24 December 2020

SYDNEY METRO CHATSWOOD TO SYDENHAM (SSI 15_7400) Track Attenuation and Operational Ground-borne Noise Review (Condition D9)

This letter documents the findings of the first part of my independent review of the proposed design objectives and track attenuation for ground-borne noise, in accordance with Condition D9 of planning approval SSI 15-7400.

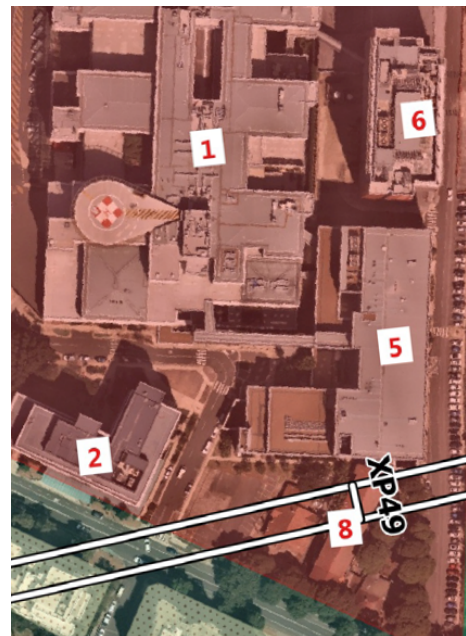
The figure to the right is an extract from the hospital map showing the alignment of the Sydney Metro tunnels and the hospital buildings closest to the tunnels.

The numbered buildings shown on the map are: 1) Acute Services Building (ASB), 2) Community Health Centre, 5) Clinical Services Building (CSB), 6) Kolling Institute, 8) Herbert Street Clinic. (Note: buildings 3, 4 and 7 are further from the tunnels).

The metro tunnels are shown in white and “XP49” shows the location of cross passage 49, directly below the Herbert Street Clinic.

The table on the next page shows the ground-borne noise and vibration sensitivity of these facilities, the criteria proposed by Sydney Metro and my assessment of whether these are appropriate.

Building	Ground-borne noise sensitivity	Criteria proposed by Sydney Metro (dBL _{Amax,S95%})	My assessment	Ground-borne vibration sensitivity	Criteria proposed by Sydney Metro	My assessment
1 (ASB)	Patient wards (Note 1)	35	Appropriate	Sensitive equipment	Note 2	Appropriate
2	Medical facility	40 - 45	Appropriate	Human comfort	103dBV	Appropriate
5 (CSB)	Patient wards	35	Appropriate	Human comfort	103dBV	Appropriate
6	Medical facility	40 - 45	Appropriate	Sensitive equipment	Note 2	Appropriate
8	Patient wards	35	Appropriate	Human comfort	103dBV	Appropriate

Note 2: The EIS adopted a screening criterion of Vibration Criterion (VC) Curve C for sensitive equipment at medical facilities. Having visited the facility I consider that this is appropriate. I also note that tunnelling and cross passage excavation activities generate significantly higher vibration levels than future train operations and I understand that there were no vibration impacts on sensitive equipment during construction.

The ground-borne noise and vibration predictions at the Royal North Shore Hospital show compliance with the applicable design goals at all affected buildings.
